Monitoring Report – Year 6
FINAL VERSION
Edwards-Johnson Mitigation Project
Calendar Year of Data Collection: 2023

RE: WLS Responses to NCDEQ DMS Review Comments for Task 12 Draft Monitoring Report Year 6 for the Edwards-Johnson Mitigation Project, NCDEQ DMS Full-Delivery Project ID #97080, Contract #006825, Neuse River Basin, Cataloging Unit 03020201, Johnston County, NC

Under this cover, we are providing our written responses to NCDEQ DMS's review comments on the Boundary Inspection Report Year 6 below. Each of the DMS review comments is copied below in **bold** text, followed by the appropriate response from WLS in regular text:

Figure 1: Current Condition Plan View (CCPV)

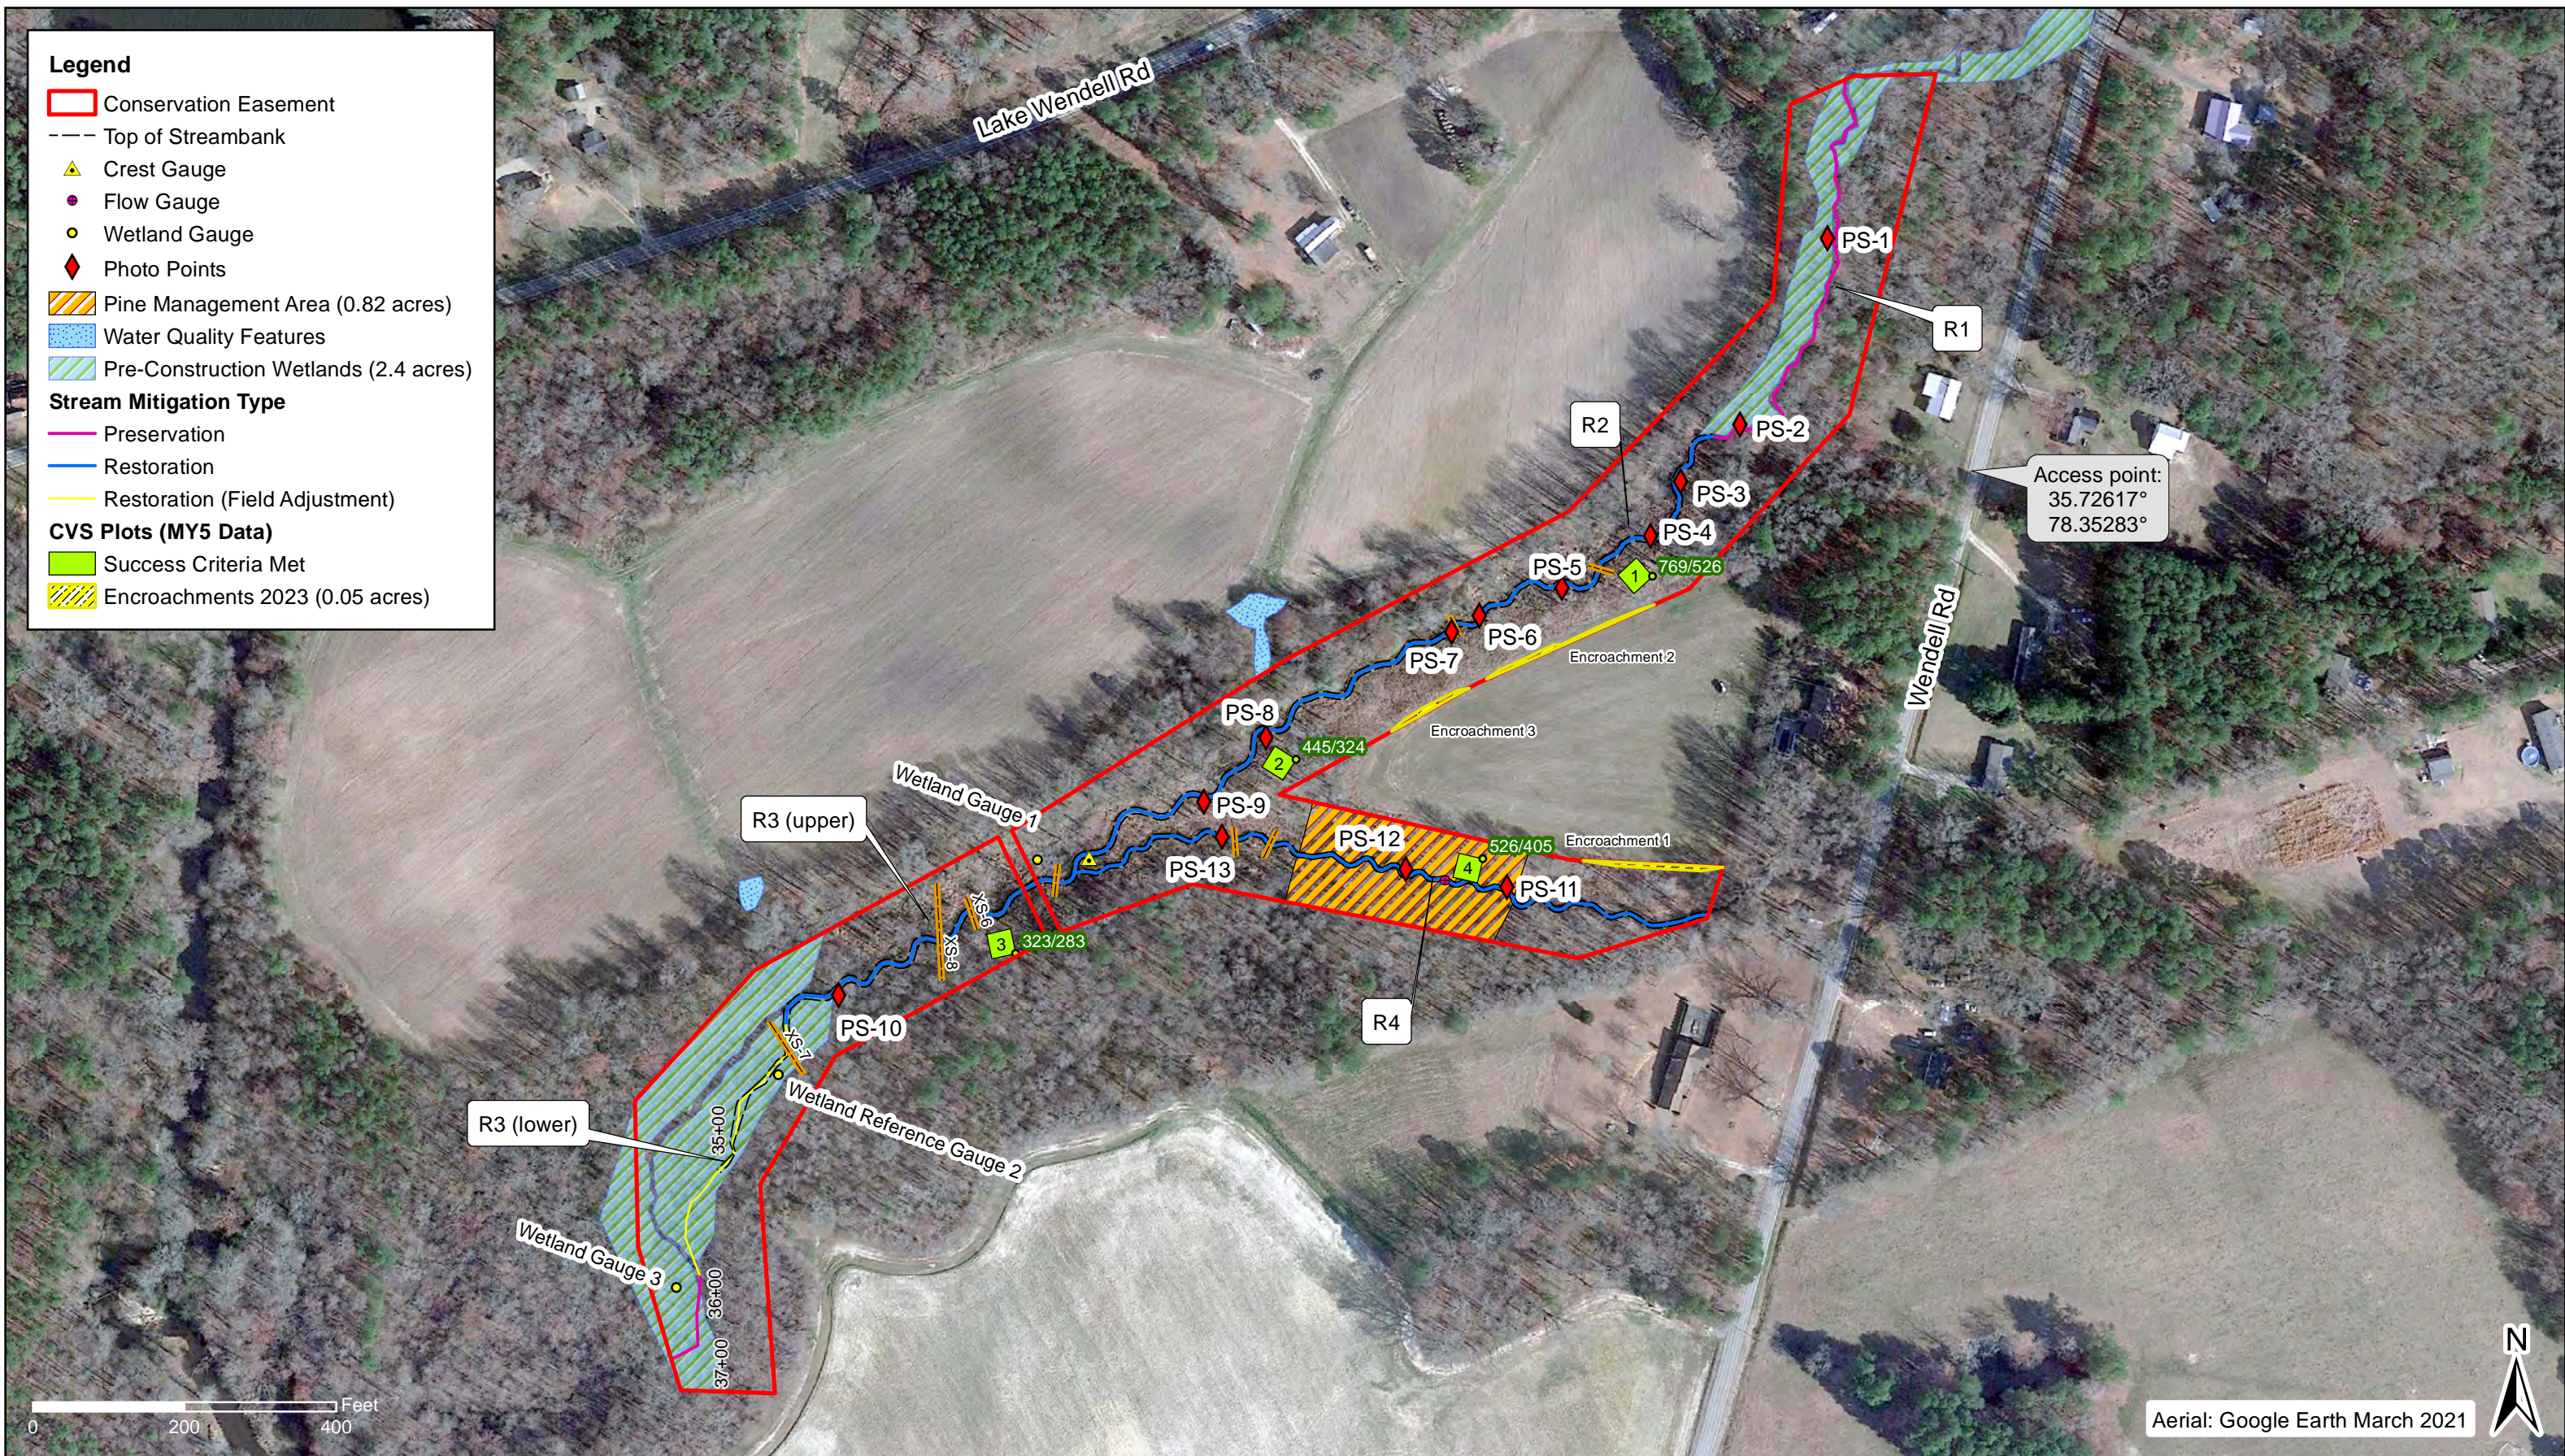
- 1. Appendix B, Table 5e: Please update the table with the correct CCPV depiction for the encroachment areas.** WLS Response: The table has been updated with the correct CCPV depiction for the encroachment areas.
- 2. Appendix D, Figure 4: Please update with rainfall through November if possible.** WLS Response: Rainfall through November 2023 has been updated in the Appendix D Rainfall Table.
- 3. Reminder to update the bond through MY6 prior to invoicing.** WLS Response: WLS will update the bond prior to invoicing.

FIGURE
1

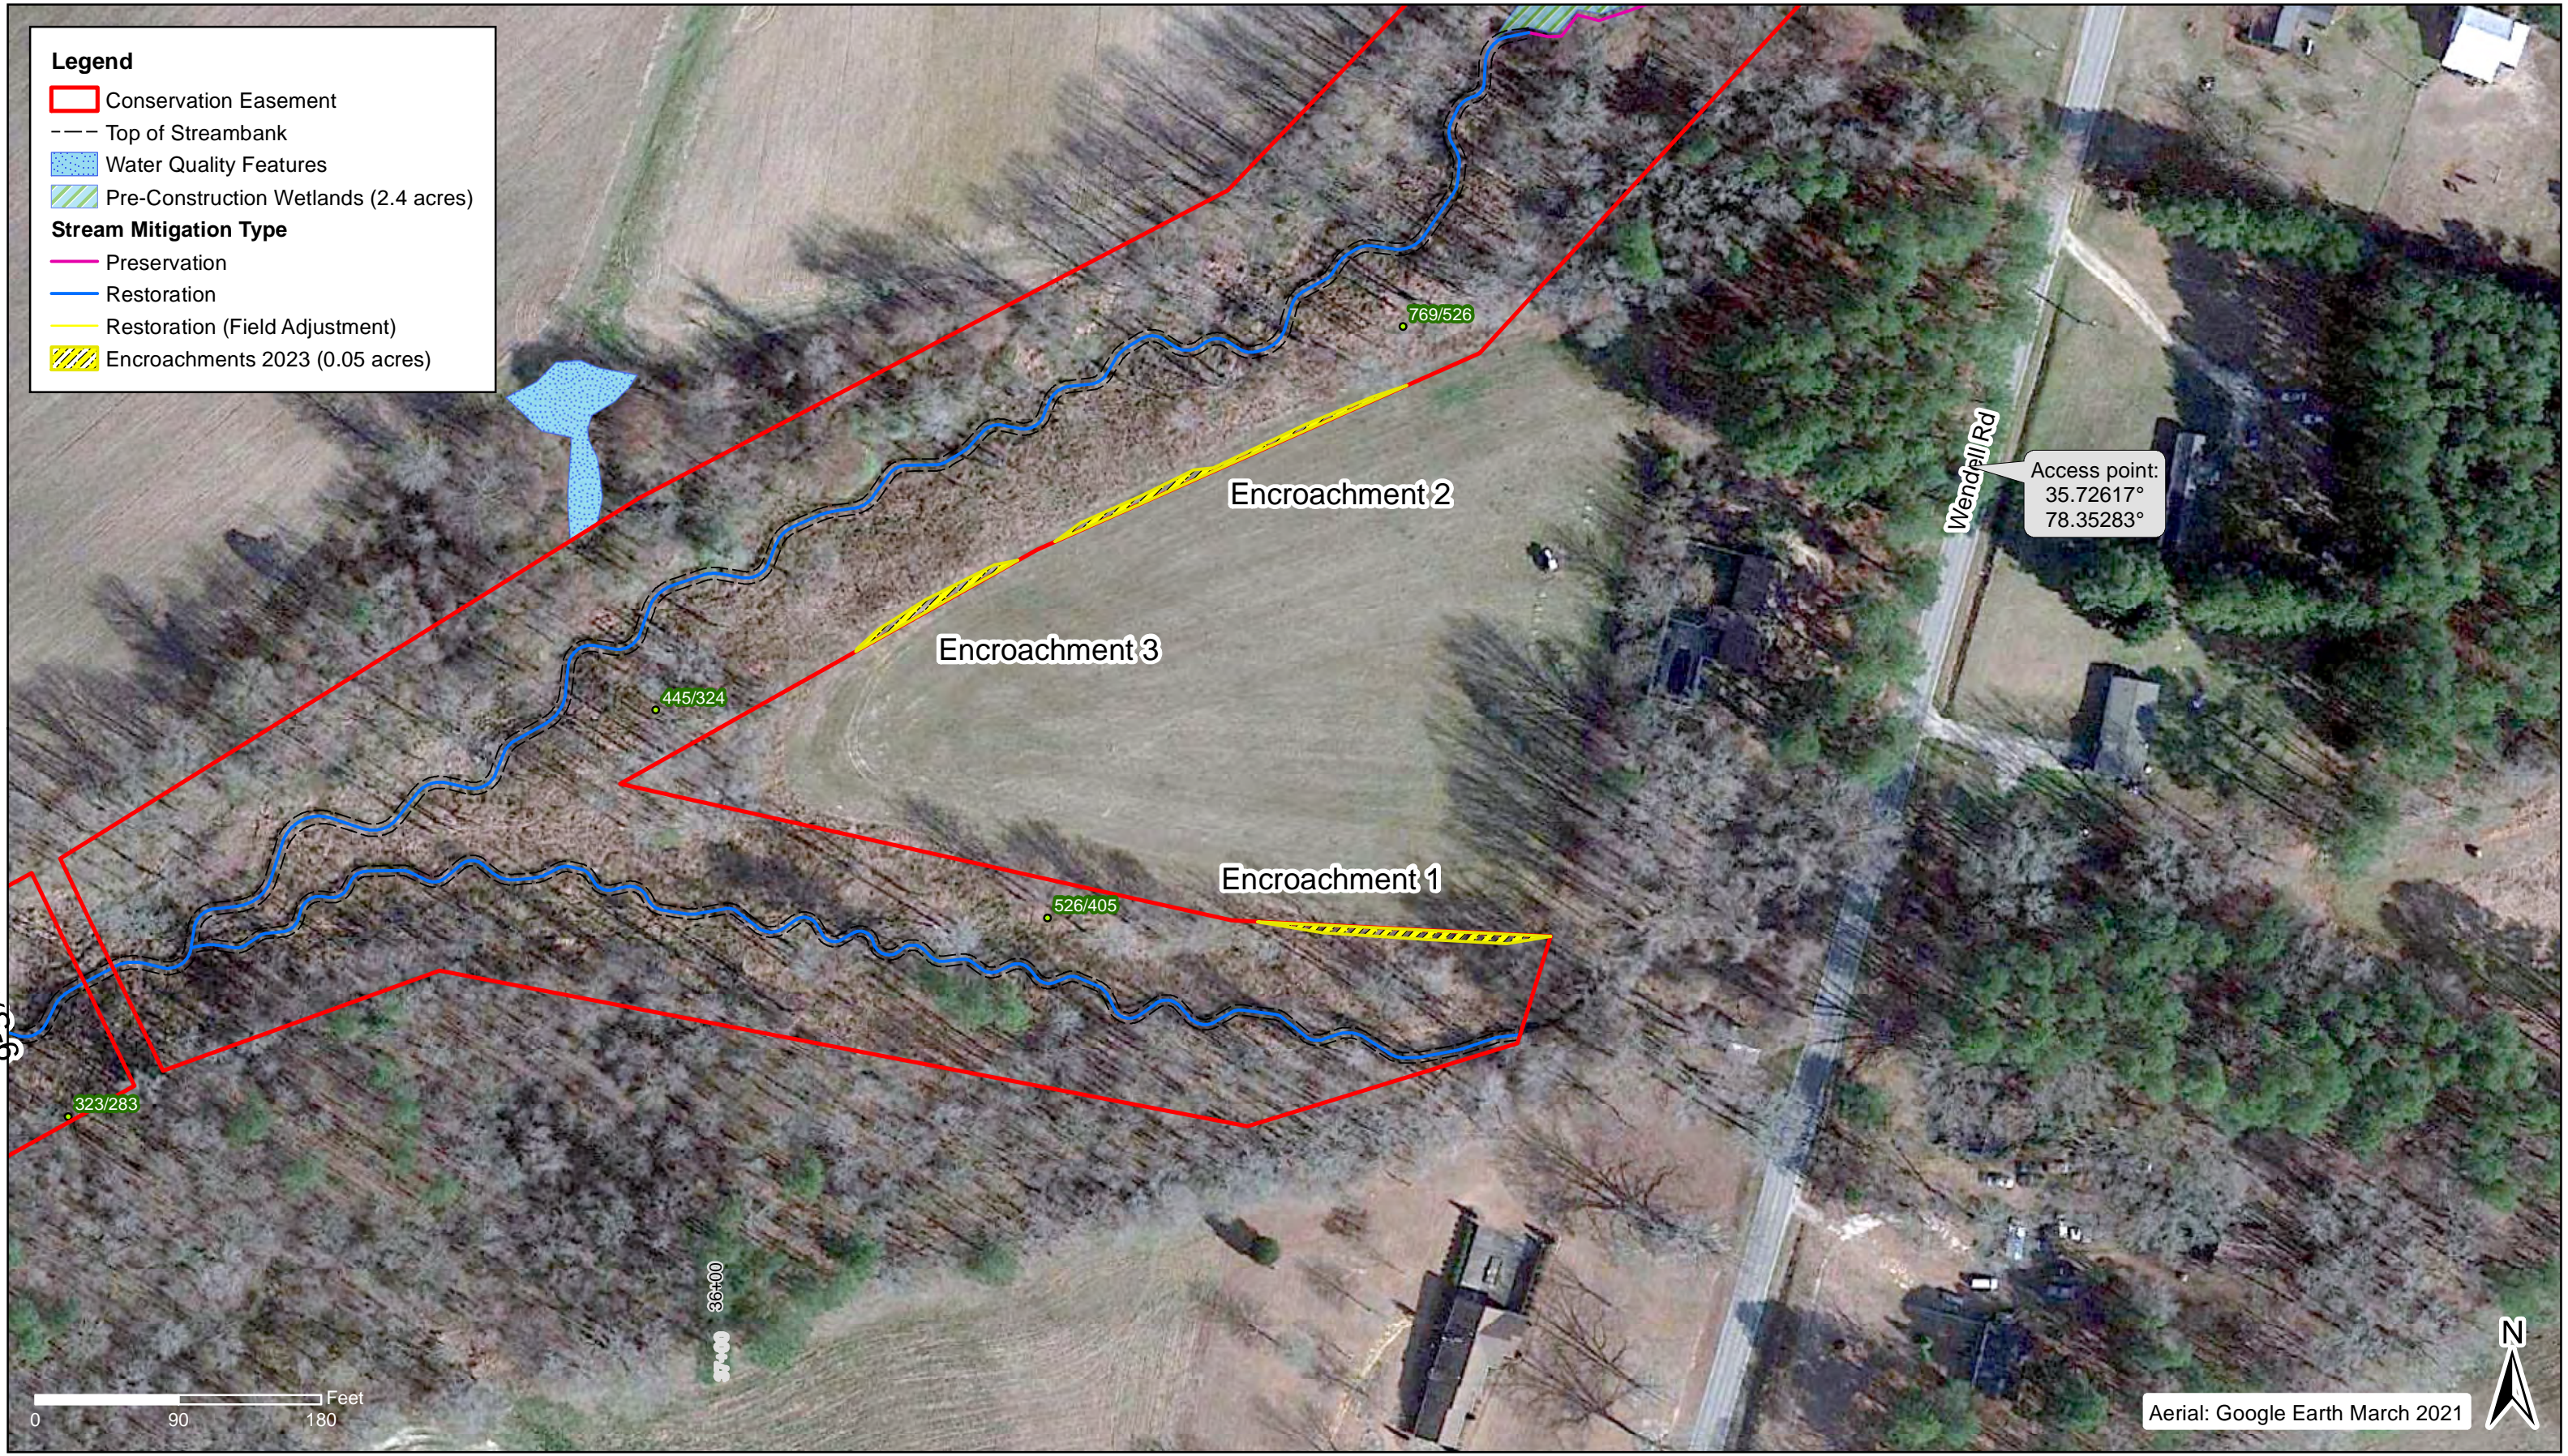
- 1. Inform the provider of the mapping discrepancy and validate survey/GIS mapping for the site. Resolve all property issues prior to closeout.** WLS response: Map discrepancies will be evaluated and addressed prior to submittal of the MY6 Draft Monitoring Report this fall.

- 2. Recommend adding supplemental posts/horse tape markings at the field encroachment areas. Communication should be initiated between the provider and the farmer to minimize the potential for future/ongoing encroachment.** WLS response: Posts and horse tape were added along field edge in encroachment areas. The total encroachment areas added up to approximately 0.05 acres. WLS will continue to monitor these areas during site visits to ensure no encroachments continue and will contact the landowner as a precaution.
